DRAINAGE PLAN
STA. 145+00 TO 150+00

FARRINGTON HIGHWAY INTERSECTION IMPROVEMENTS
AT NANAKULI AVENUE AND HALEAKALA AVENUE
Federal-Aid Project No. STP-093-1(22)

CONTRACT CHANGE ORDER NO. 27
Attachment 1

DRAINAGE PLAN
STA. 150+00 TO 155+00

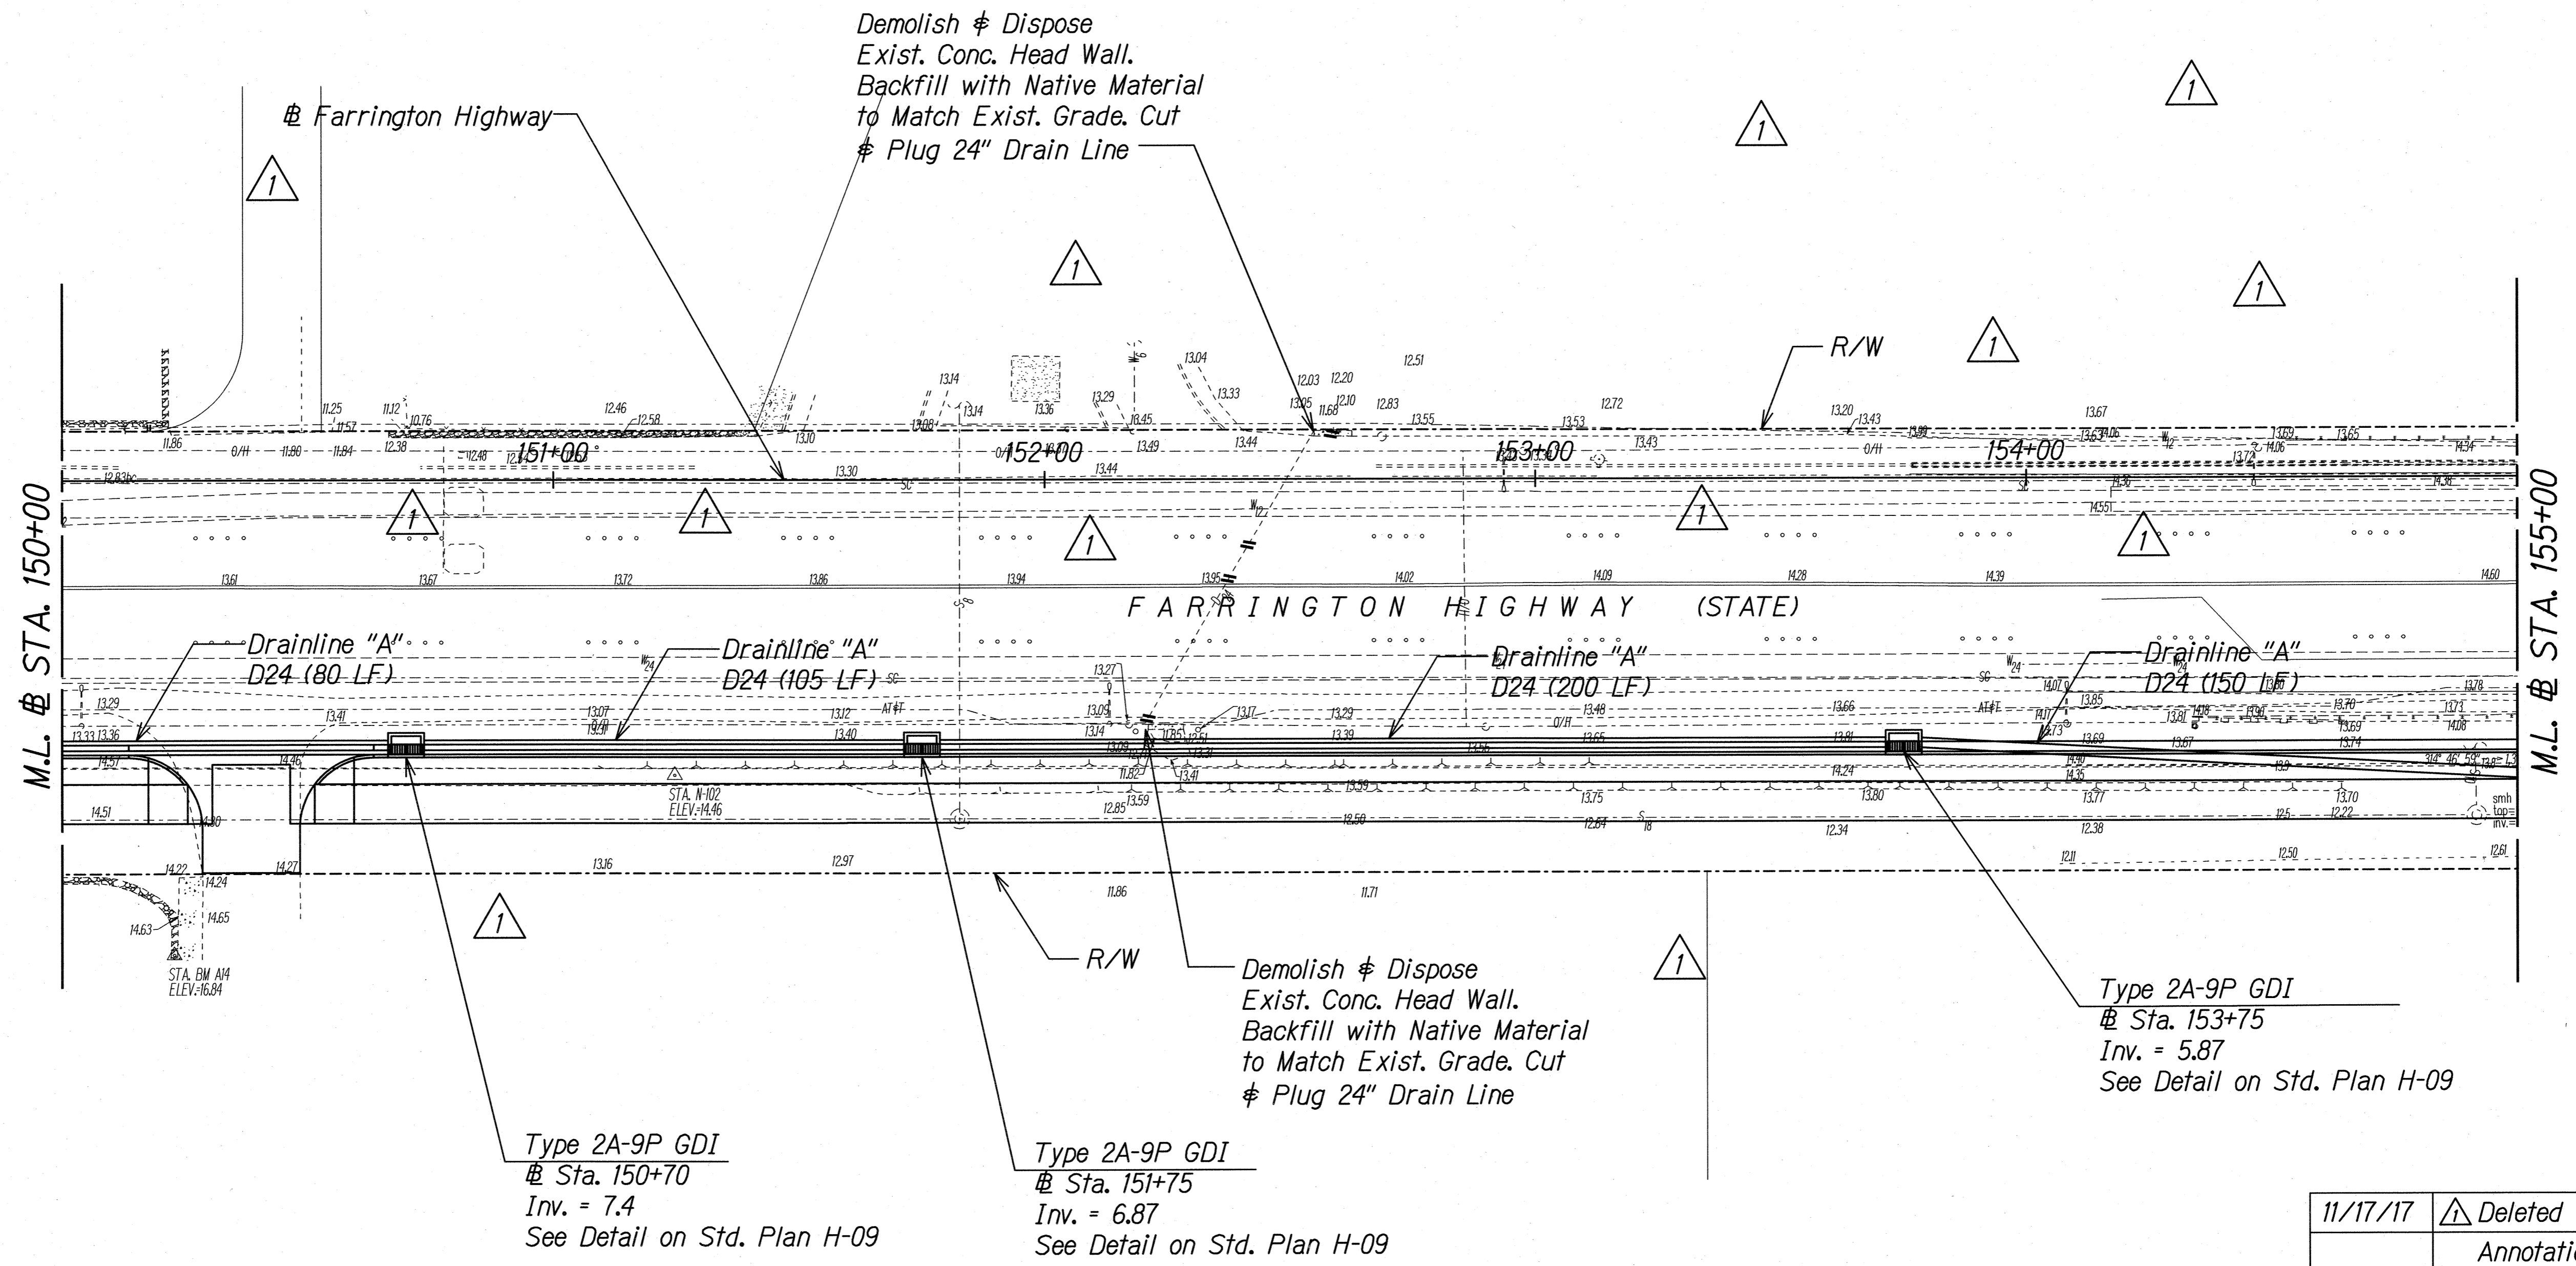
11/17/17	Deleted Drainline and Annotations
Date	Revision

DRAINAGE PLAN
STA. 155+00 TO 160+00

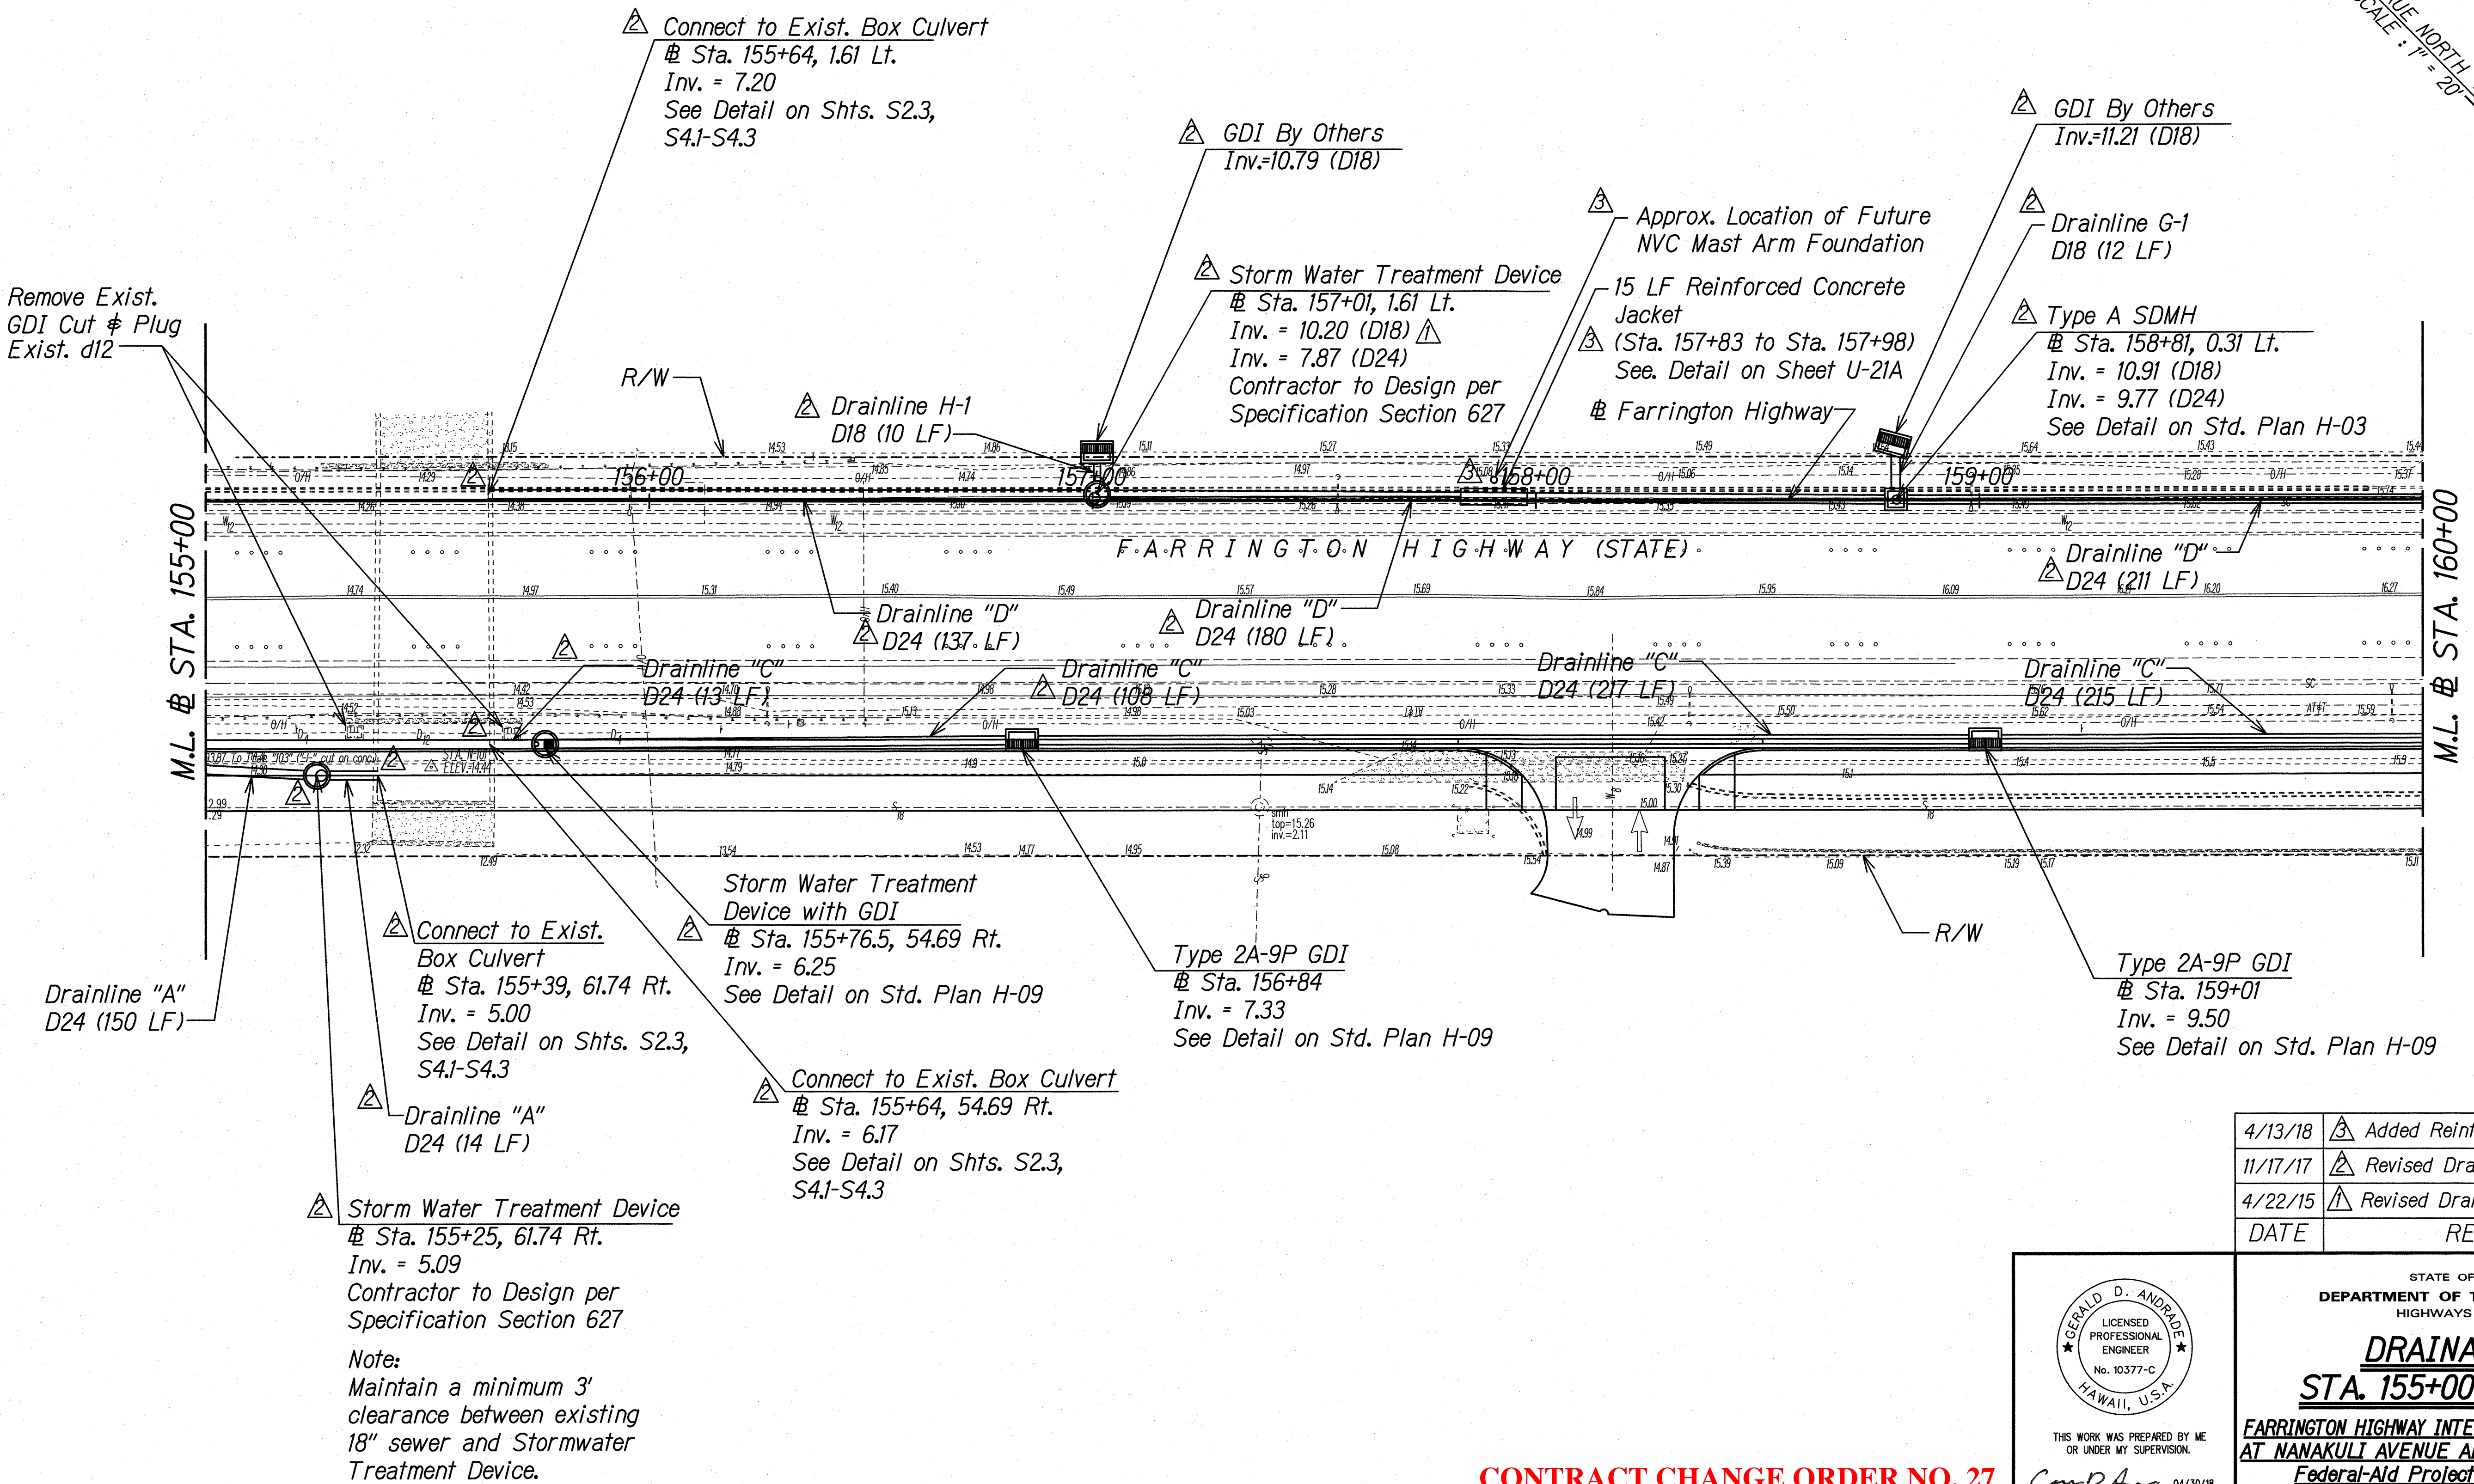
DATE	REVISION
4/13/18	Added Reinforced Concrete Jacket
11/17/17	Revised Drainline "D"
4/22/15	Revised Drainline "D"

DRAINAGE PLAN
STA. 160+00 TO 164+00

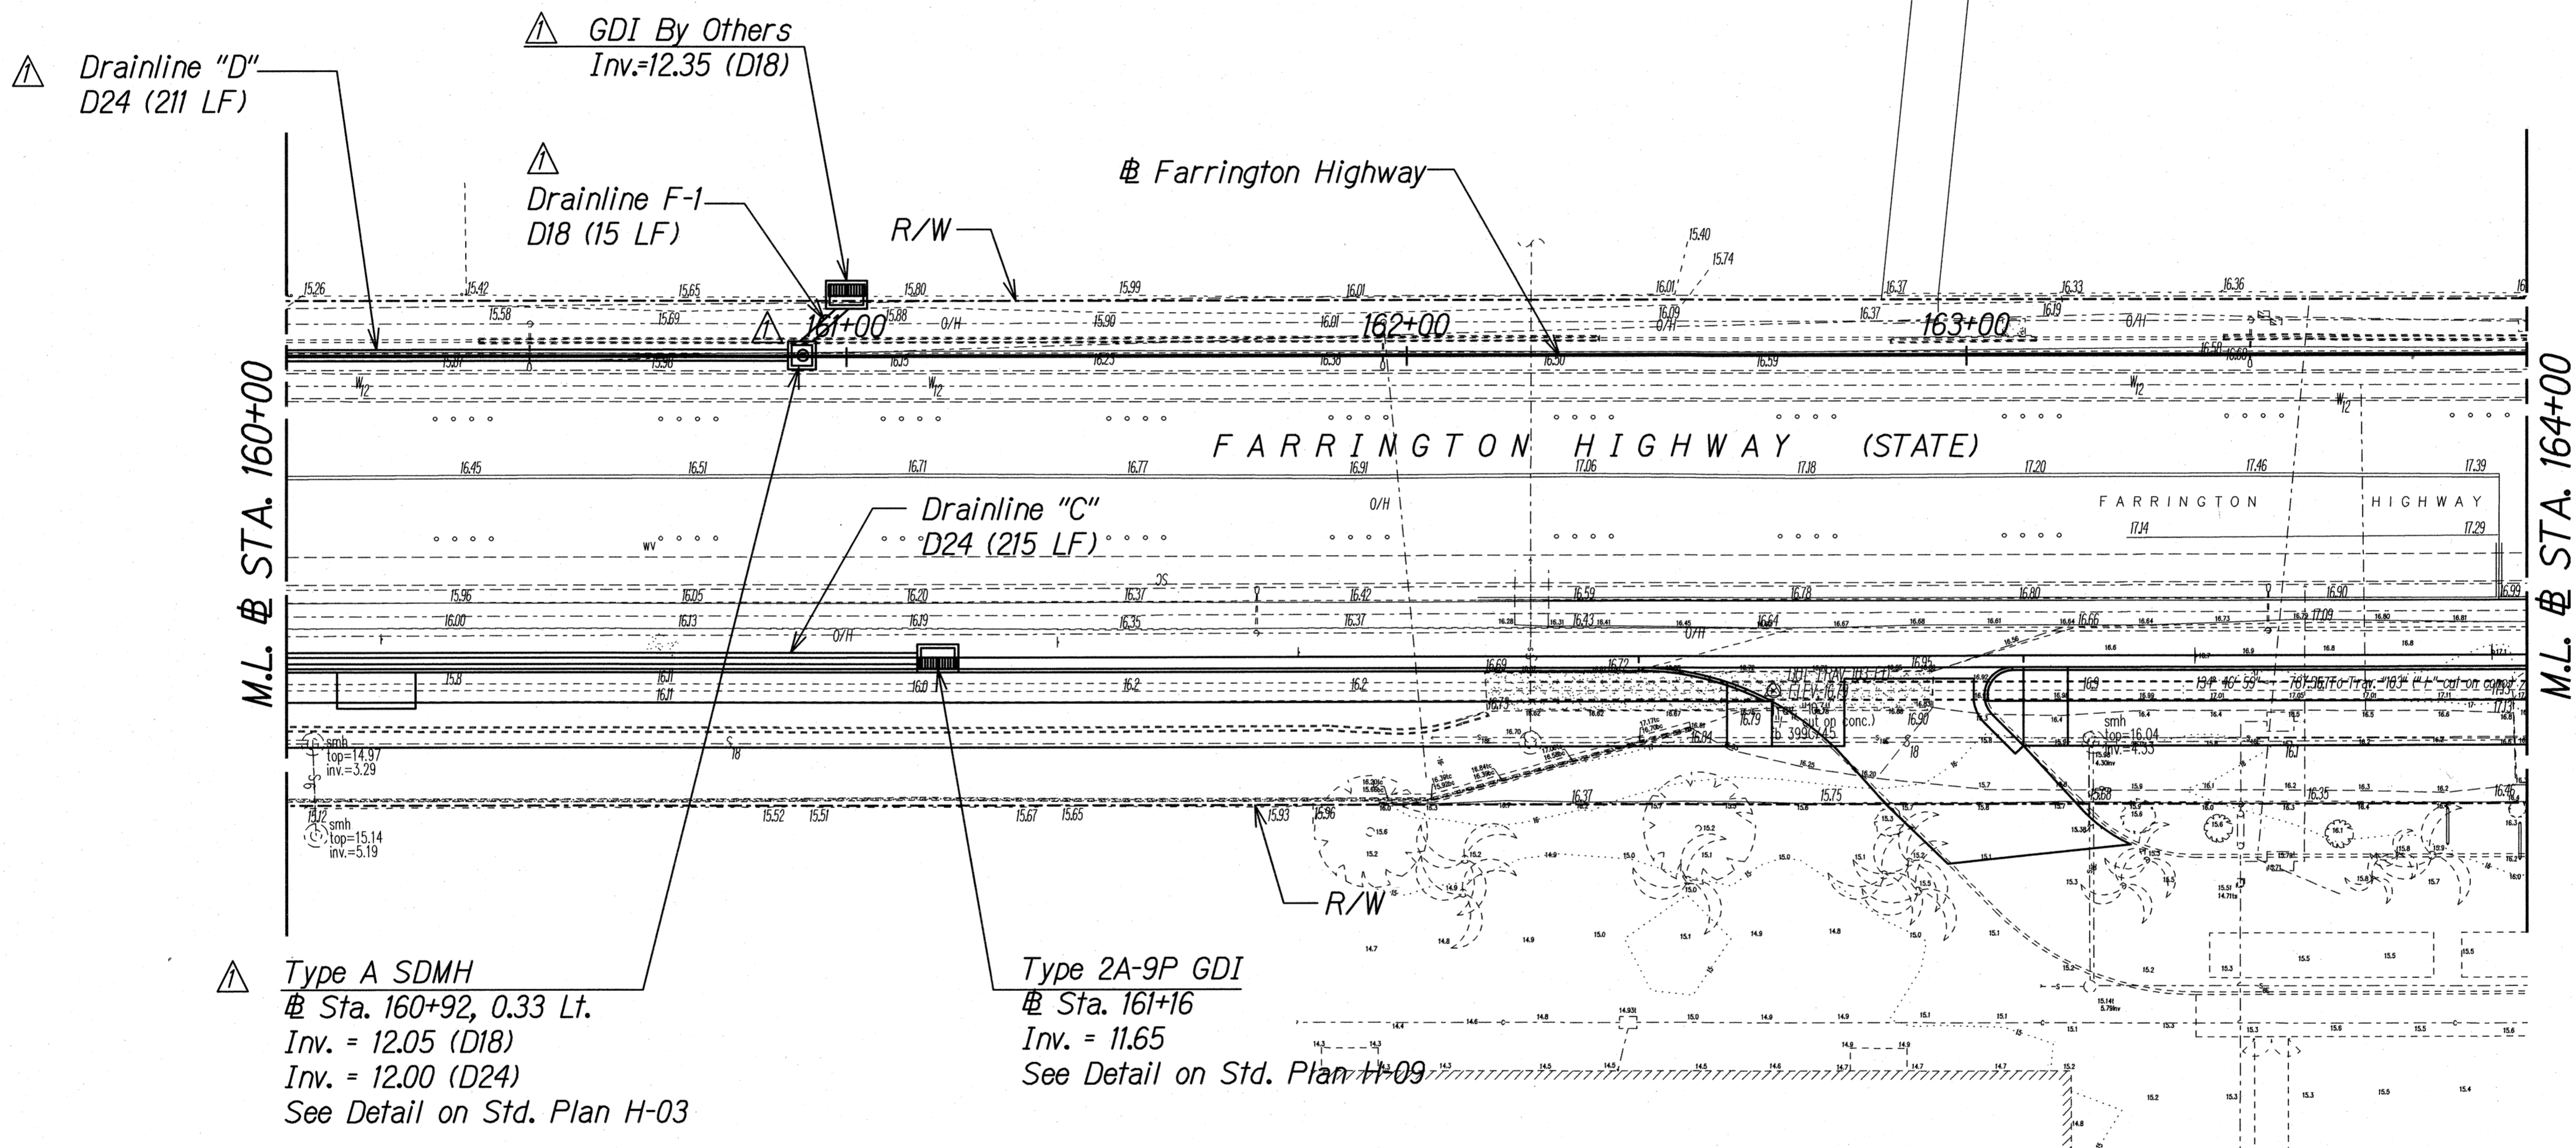
11/17/17	△ Revised Drainline "D"
DATE	REVISION

△ Type A SDMH
@ Sta. 160+92, 0.33 Lt.
Inv. = 12.05 (D18)
Inv. = 12.00 (D24)
See Detail on Std. Plan H-03

Type 2A-9P GDI
@ Sta. 161+16
Inv. = 11.65
See Detail on Std. Plan H-03
